**JOINT REGIONAL PLANNING PANEL  
(Sydney East)**

<b>JRPP No</b>	<b>2011SYE010</b>
<b>DA Number</b>	<b>8.2010.18.2</b>
<b>Local Government Area</b>	<b>Mosman Municipal Council</b>
<b>Proposed Development</b>	<b>Modification of consent comprising change in number of dwellings from 35 to 29, changes to dwelling mix, internal configuration, building envelope and facade</b>
<b>Street Address</b>	<b>100 Glover Street</b>
<b>Applicant/Owner</b>	<b>Applicant – Mark Monk c/ Helm Pty Ltd</b> <b>Owner – Helm No. 3 Pty Ltd</b>
<b>Number of Submissions</b>	<b>Three (3)</b>
<b>Recommendation</b>	<b>Approval with Conditions</b>
<b>Report by</b>	<b>Duncan Livingstone, Town Planner</b>

**TITLE:** 100 Glover Street

**PROPOSAL:** Modification of a consent comprising change in number of dwellings from 35 to 29, changes to dwelling mix, internal configuration, building envelope and facade

**Figure 1:** Reduced extent of roofing

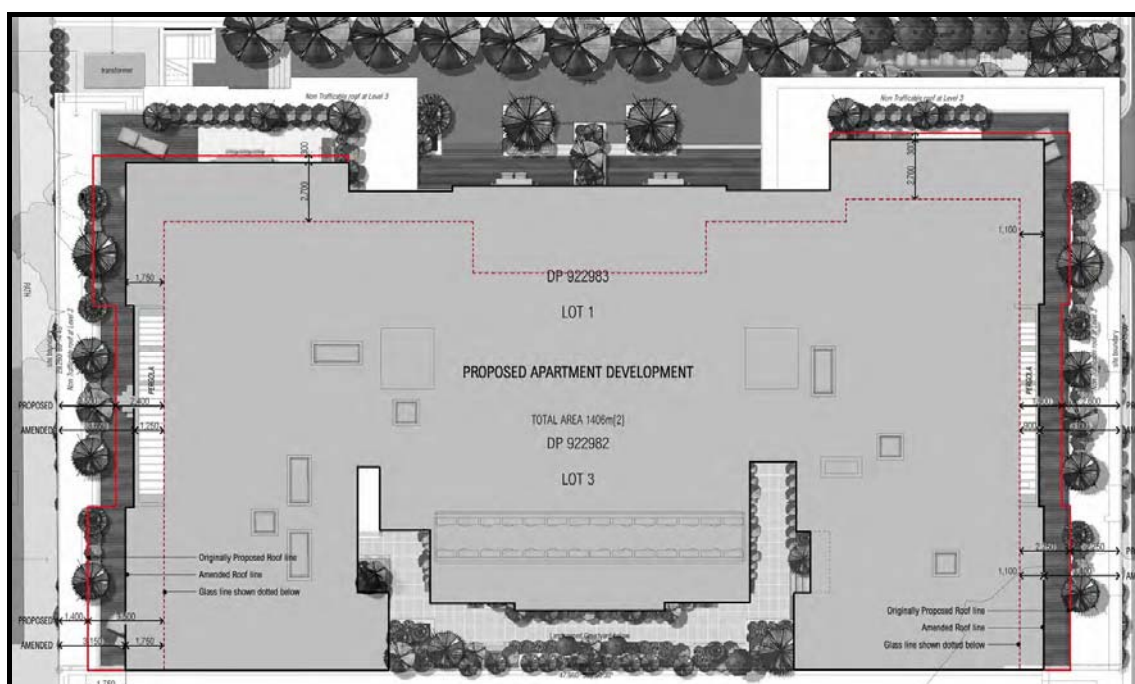
Council Request	Applicant Response
Reduced extent of roofing so that it extends no further than the proposed building alignment of the dwellings at Level 3.	<p>Within their submission the applicant agreed that the extent of roofing be reduced by way of condition. In addition an indicative plan was furnished. The reduced extent of roofing is provided below.</p> <p>Northern extent of roofing reduced from the originally proposed 3.5m – 2.4m overhang to a 1.75m – 1.25m overhang.</p> <p>Eastern extent of roofing overhang reduced by 300mm.</p> <p>Southern extent of roofing reduced from the originally proposed 2.25m – 1.9m overhang to a 1.1m – 0.9m.</p> <p>(Please refer to Figure 1)</p>
For safe and amenable pedestrian access provide a 1.2m width pedestrian path adjacent to the Lindsay Lane frontage.	Pedestrian access for dwellings G07 and G08 to Lindsay Lane deleted. Width of pedestrian path unaltered.

- 2A To reduce discrepancies between the elevation plans and the roof/site plan, the extent of the roofing shall be constructed in accordance with Plan No. S96.01 – Issue C, dated 22 March 2011, noting the required reduction of roof extent in conditions 2B and 2C. Details are to be included in the Construction Certificate application.
